1990 Corvette: Service Bulletin: SIR Diagnostics and Procedures to Prevent Codes 16 and 26 Due to Corrosion Revised

Subject: SERVICE MAN. UPDATE SEC.9J A/B REV. SIR DIAGNOSTIC PROCEDURE

Model and Year: 1990 CORVETTE

Bulletin Number: 90-436-9J - (11/07/1991)

FORWARD DISCRIMINATING SENSORS Figures 1 & 2 -----

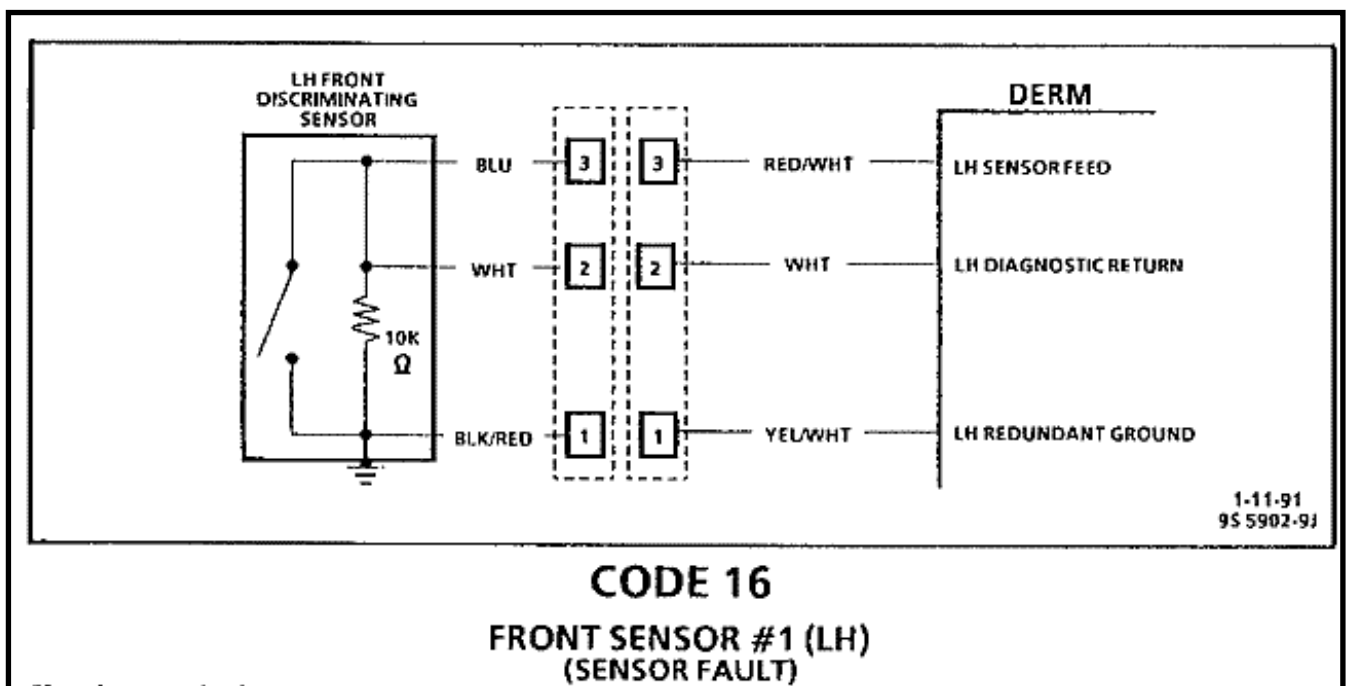
Caution should be used to assure proper location of sensors to the front frame rails. The keying of the sensors to the frame rails through the differently sized mounting bolt holes in the sensor mounting plate should never be modified in the field.

1. Apply a thin layer of special grease P/N 12345579 to the frame rail mounting surface and the mounting flange of the sensor. Do not apply the grease to the mounting bolts or holes.
2. Forward discriminating sensor, with arrow pointing toward front of vehicle.
3. External tooth lock washers, P/N 11501869 (8 mm) and 121753 (6 mm) to mounting bolts.
4. Sensor mounting bolts. Ensure that washers are between bolt head and sensor mounting flange, not between mounting flange and frame rail.

- Proper operation of the forward discriminating sensor requires the sensor be rigidly attached to the vehicle structure and that the arrow on the sensor be pointing toward the front of the vehicle.

1. Apply a thin layer of special grease P/N 12345579 to the frame rail mounting surface and the mounting flange of the sensor. Do not apply the grease to the mounting bolts or holes.
2. Forward discriminating sensor, with arrow pointing toward front of vehicle.
3. External tooth lock washers, P/N 11501869 (8 mm) and 121753 (6 mm) to mounting bolts.
4. Sensor mounting bolts. Ensure that washers are between bolt head and sensor mounting flange, not between mounting flange and frame rail.

Tighten

- Front (13 mm head) bolt to 25 N.m (19 lb. ft.) - Rear (10 mm head) bolt to 14 N.m (125 lb. ft.)
5. Sensor electrical connection, then clip completed connection into retainer.
 6. Position windshield washer reservoir; install retaining bolts.

CODE 16 FRONT SENSOR #1 (LH) (SENSOR FAULT)

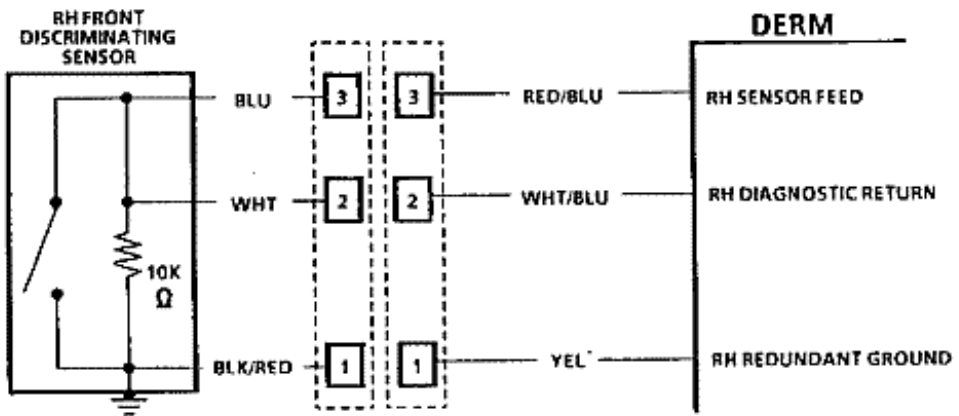
- 1
- IGNITION "OFF."
 - DISCONNECT SENSOR CONNECTOR.
 - USING ADAPTERS FROM J 37808-10 AND DVM J 34029-A OR DVM J 39200, MEASURE THE RESISTANCE BETWEEN TERMINALS IN THE SENSOR PIGTAIL CONNECTOR AS SHOWN BELOW. NOTE MEASUREMENTS FOR EACH CHECK.

SENSOR TERMINALS	RESISTANCE
1 AND 2	ABOUT 10,000 Ω
1 AND 3	ABOUT 10,000 Ω
2 AND 3	LESS THAN 1 Ω

- 3
- REMOVE SENSOR; REFER TO "LEFT SENSOR" ON ATTACHED PAGES.
 - CLEAN ANY PAINT AND/OR CORROSION FROM SENSOR AND FRAME RAIL MOUNTING POINTS AND MOUNTING BOLTS.
 - INSTALL SENSOR; REFER TO "LEFT SENSOR" ON ATTACHED PAGES TO APPLY SPECIAL GREASE AND LOCK WASHERS UPON INSTALLATION TO HELP PREVENT RECURRENCE OF CODE 16 DUE TO CORROSION.
 - CLEAR CODES (TECH 1 PREFERRED).
 - IGNITION "OFF," THEN "ON."
 - DOES CODE 16 RESET?

- 4
- REMOVE SENSOR; REFER TO "LEFT SENSOR" ON ATTACHED PAGES.
 - CLEAN ANY PAINT AND/OR CORROSION FROM FRAME RAIL MOUNTING POINTS AND MOUNTING BOLTS.
 - INSTALL NEW SENSOR; REFER TO "LEFT SENSOR" ON ATTACHED PAGES TO APPLY SPECIAL GREASE AND LOCK WASHERS ON INSTALLATION TO HELP PREVENT RECURRENCE OF CODE 16 DUE TO CORROSION.
 - CLEAR CODES (TECH 1 PREFERRED).
 - IGNITION "OFF," THEN "ON."
 - DOES CODE 16 RESET?
